SR 141/Bethelview Road @ SR 9 (Atlanta Highway) Intersection Improvements

CSSTP-0007-00(999), P.I. No. 0007999
Forsyth County, Georgia

Value Engineering Study Report

September 2009

ALT. P-2

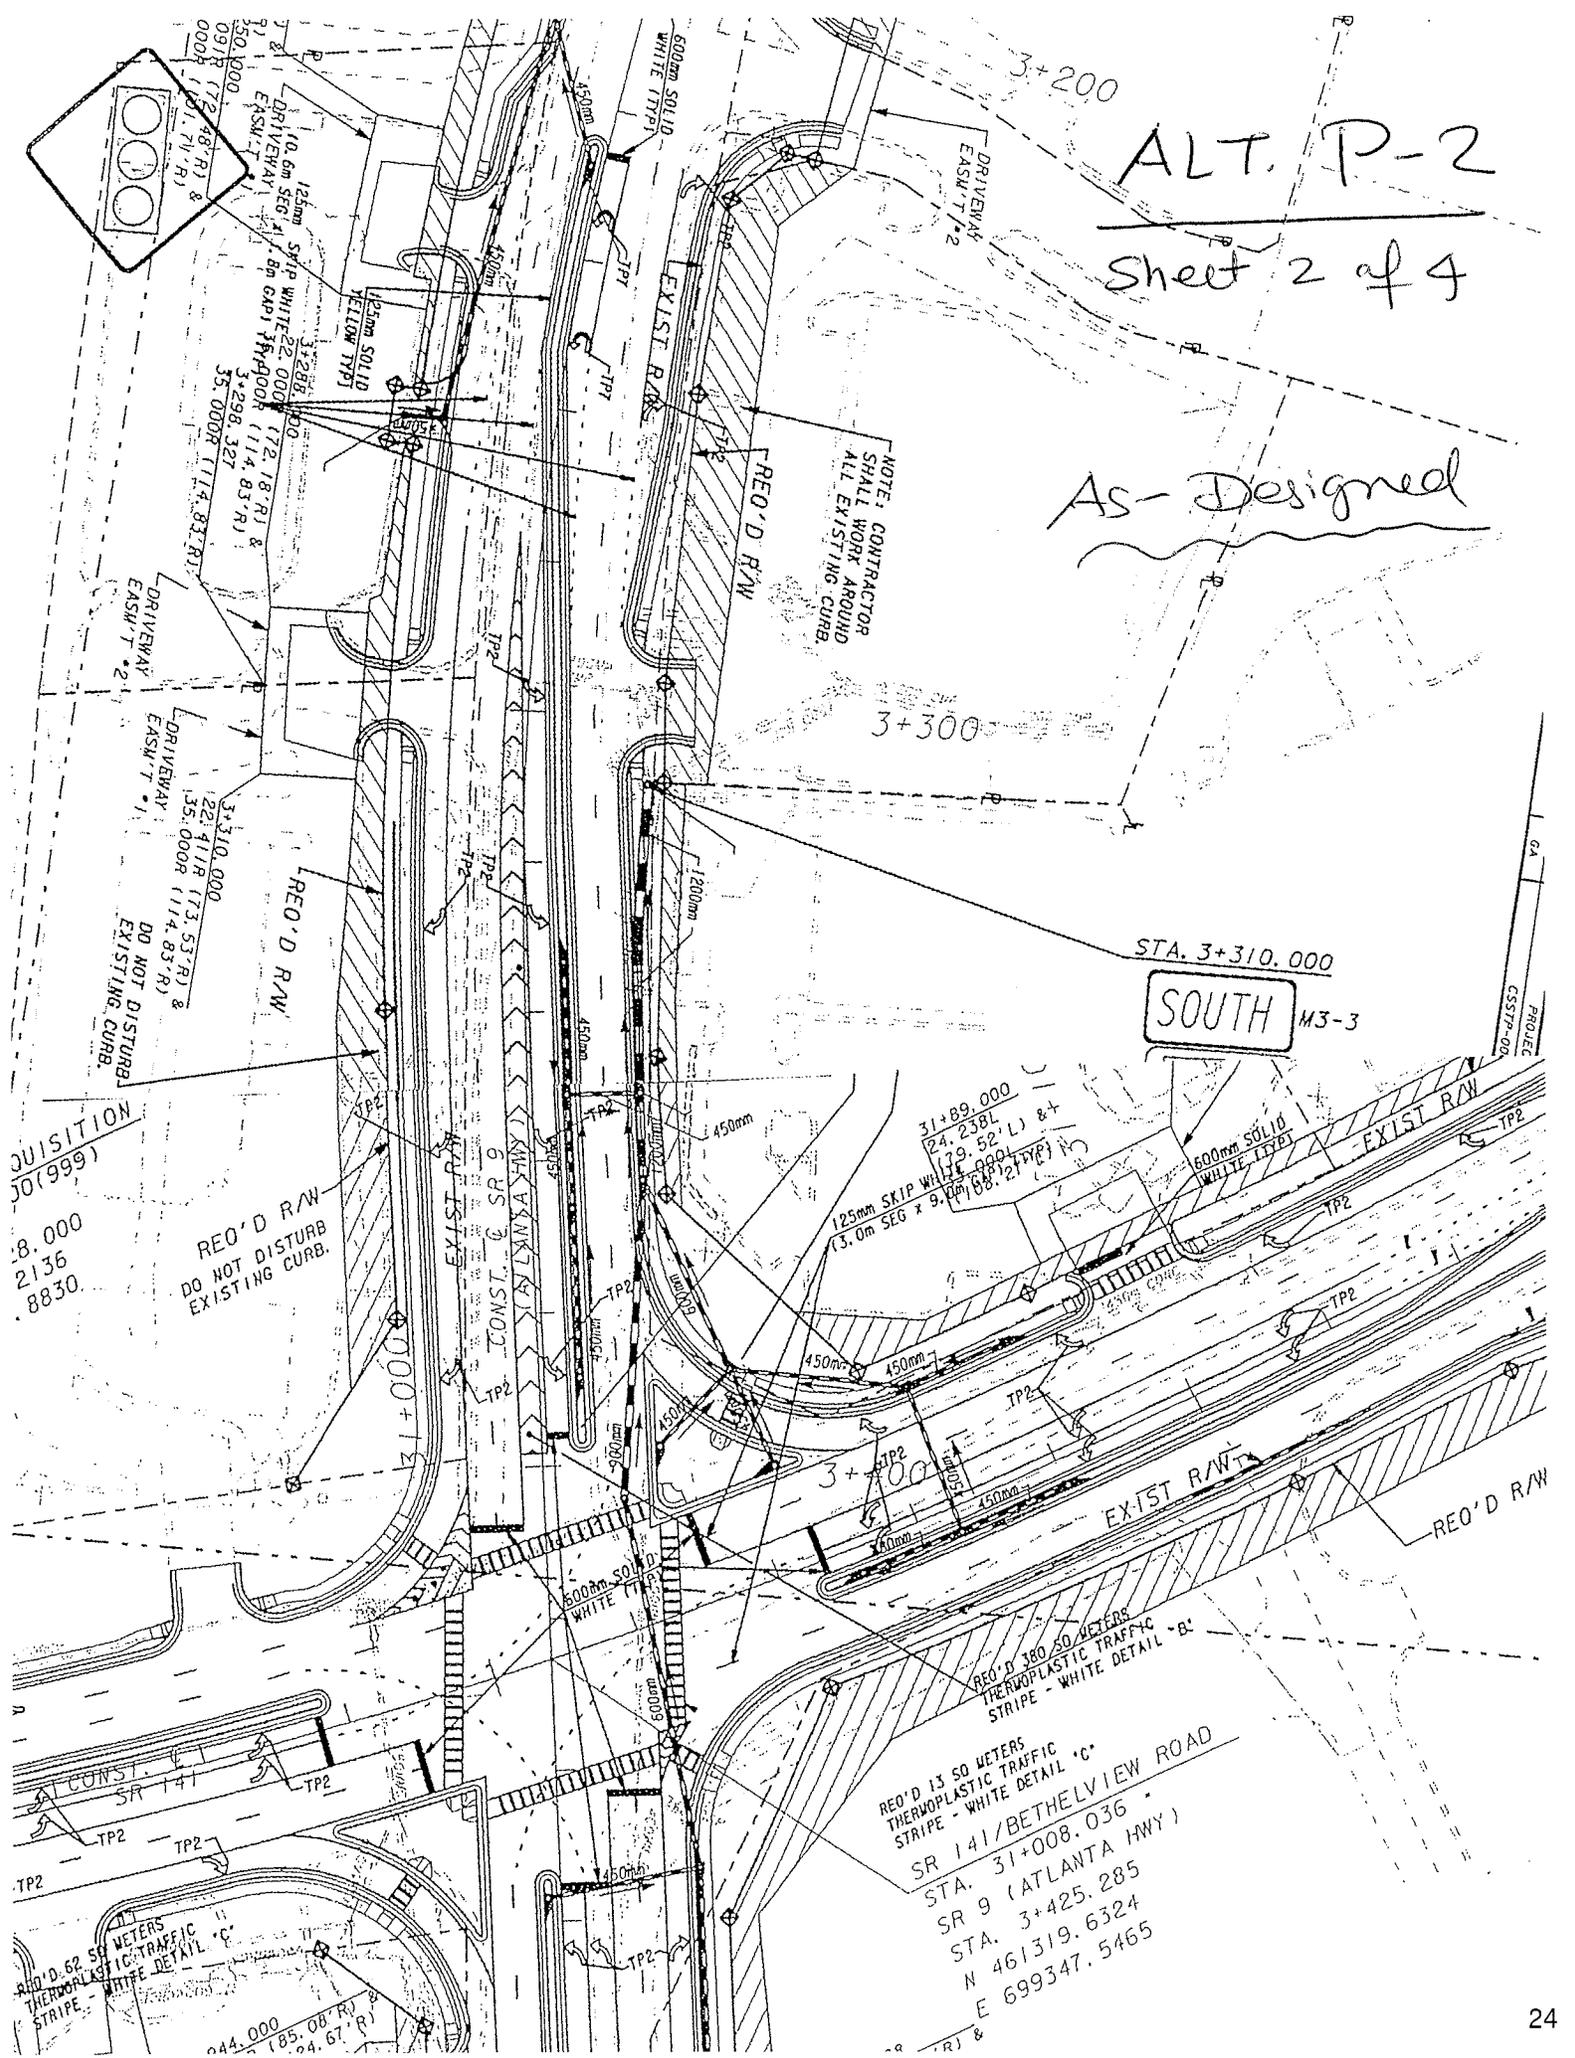
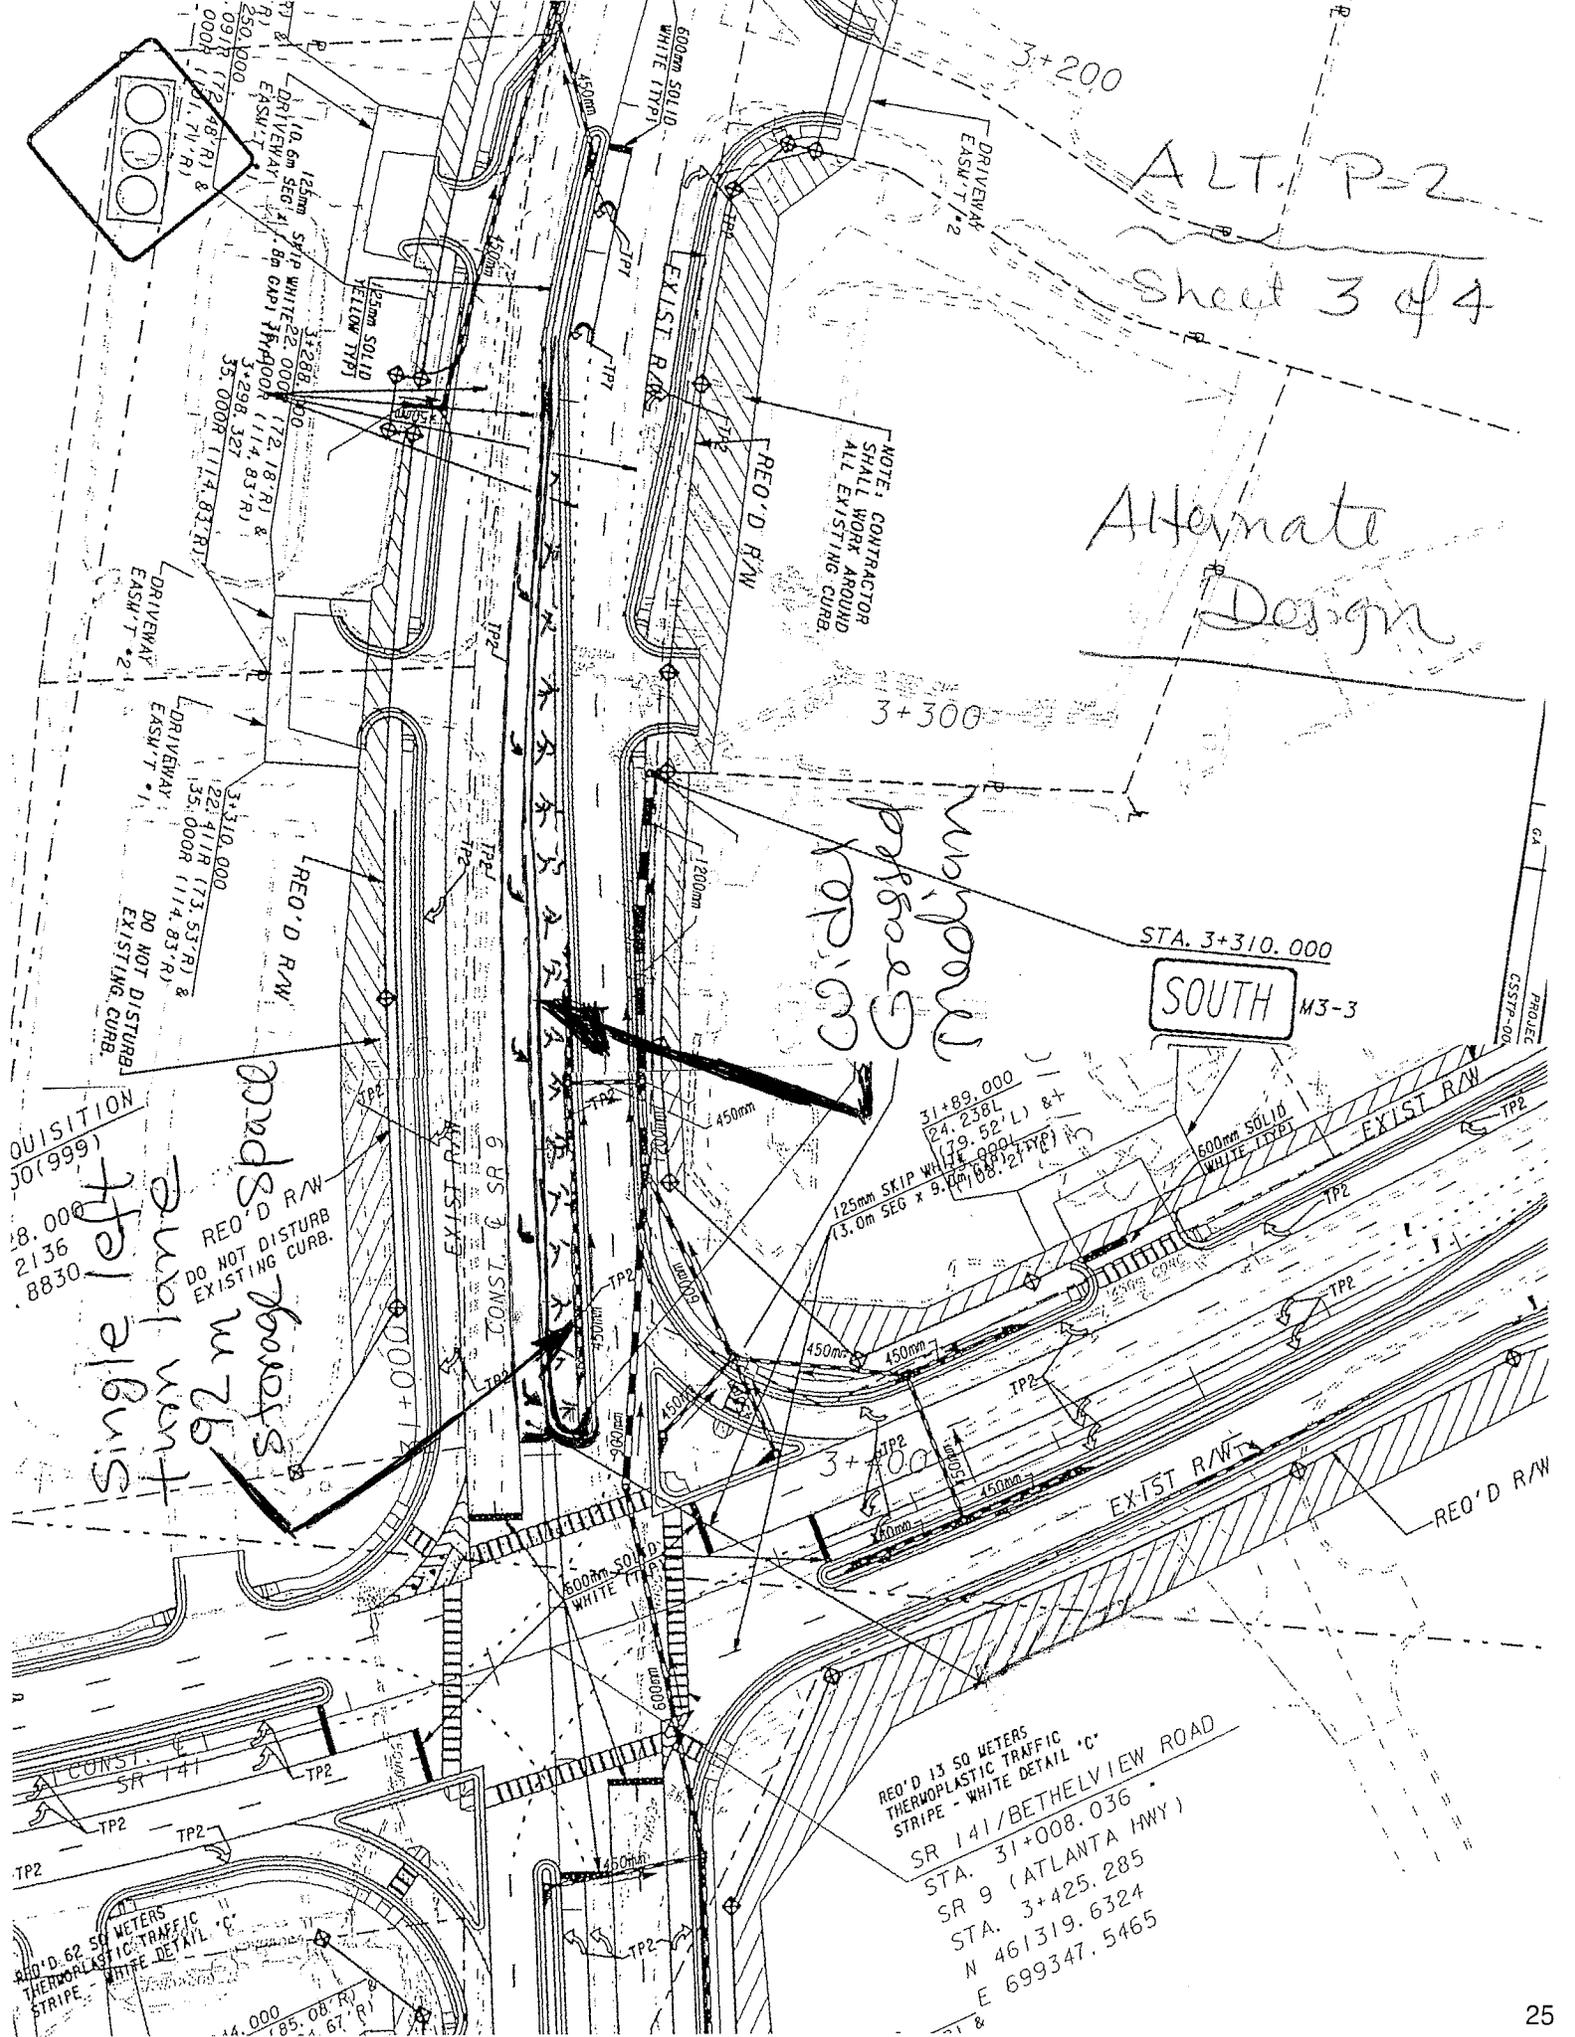
Provide two left turn lanes on westbound SR 9 at the intersection with SR 141/Bethelview Road.

Provide one left turn lane on westbound SR 9 and make the median wider.

The maximum daily hour volume (DHV) of traffic in the year 2032 during AM hours is expected to be 100 while during the PM hours it is expected to be 155. The designed storage length is 120 m. By eliminating this turn lane and converting the Chevron striped area into a left turn lane, the storage length reduces to 92 meters, still enough for 12 vehicles. On the opposite side of the intersection, there will still be two left turn lanes for the heavy traffic accessing SR 141 and GA 400.

single left
turn lane
92 m
storage space
